Access Compliance Report Public Rights-of-Way (RR Crossings)

Intersection ID: 10025333	Main Street: E_6TH_ST	Location: N/A
ADA ID: 9C15957F48C3	Overall Compliance: No	Severity Score: 0.0
Codes/Mitigation Info/Possible Solution		Field Measurements/Component Compliance

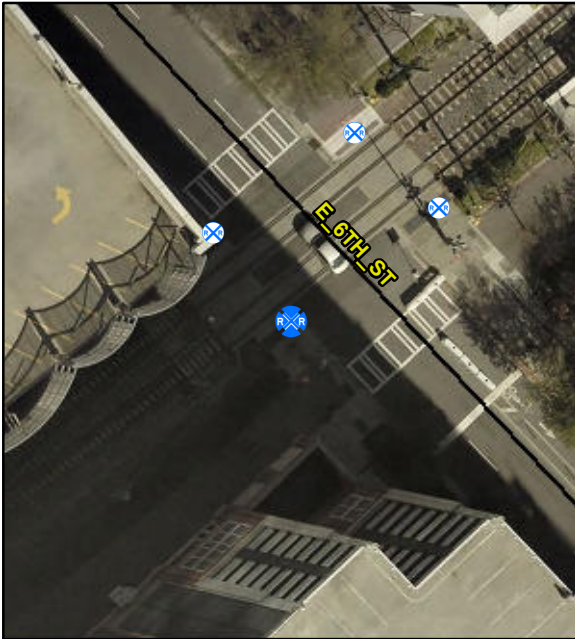
Compliance	Description	Data
Yes	DWS Provided?	Yes
Yes	DWS Contrast?	Yes
No	DWS Width (in)	No
Yes	DWS Length (in)	36.0
No	DWS Offset (in)	30.0
No	Pedestrian Gate?	No
N/A	DWS Outside Gate?	N/A
N/A	Rail Type?	LightRail
No	Flangeway Gap (in)	2.5
Yes	Sidewalk Width (in)	113.0

Remove & Replace Detectable Warning System. Provide Pedestrian Gate. Remove & Replace Walking Surface Adjacent to Rail.
